## 2 SITE CHARACTERISTICS AND SITE PARAMETERS

This chapter of the safety evaluation report (SER) documents the U.S. Nuclear Regulatory Commission (NRC) staff's review of Chapter 2, "Site Characteristics and Site Parameters," of the NuScale Power, LLC (NuScale), Standard Design Approval Application (SDAA), Part 2, "Final Safety Analysis Report (FSAR)." The staff's regulatory findings documented in this report are based on Revision 2 of the SDAA, dated April 09, 2025 (Agencywide Documents Access and Management System Accession No. ML25099A237). The precise parameter values, as reviewed by the staff in this safety evaluation, are provided by the applicant in the SDAA using the English system of measure. Where appropriate, the NRC staff converted these values for presentation in this safety evaluation to the International System (SI) units of measure based on the NRC's standard convention. In these cases, the SI converted value is approximate and is presented first, followed by the applicant-provided parameter value in English units within parentheses. If only one value appears in either SI or English units, it is directly quoted from the SDAA and not converted.

### 2.0 Site Characte

**Figure 2.5-1 NuScale horizontal (a) and vertical (b) certified seismic design response spectra 5-percent damping (after FSAR Figures 3.7.1-1 and 3.7.1-2)**

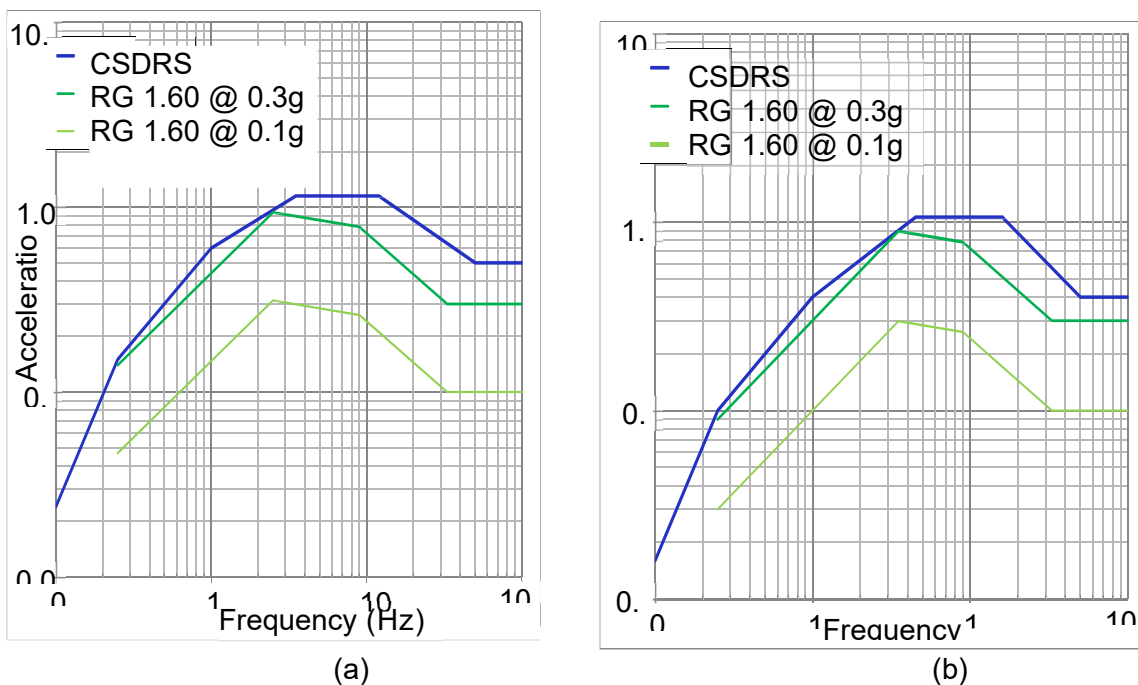
FSAR Section 2.5.2 refers to Section 3.7.1 of the FSAR for the CSDRS. FSAR Table 3.7.1-1 specifies the CSDRS that form the seismic loading design basis and can be used to compare with the site-specific GMRS and to determine the SSE. Figures 2.5-1 and 2.5-2 of this report illustrate these CSDRS.

The CSDRS and the CSDRS-HF are key design parameters as discussed in FSAR Section 3.7.1, "Seismic Design Parameters." The CSDRS are shown in FSAR Figure 3.7.1-1, "NuScale Horizontal CSDRS at 5 Percent Damping," and Figure 3.7.1-2, "NuScale Vertical CSDRS at 5 Percent Damping." The CSDRS-HF is shown in FSAR Figure 3.7.1-3, "NuScale Horizontal CSDRS-HF at 5 Percent Damping," and Figure 3.7.1-4, "NuScale Vertical CSDRS-HF at 5 Percent Damping." SDAA Tables 3.7.1-1 and 3.7.1-2 provide the horizontal and vertical control points for the CSDRS and CSDRS-HF at 5 percent damping.
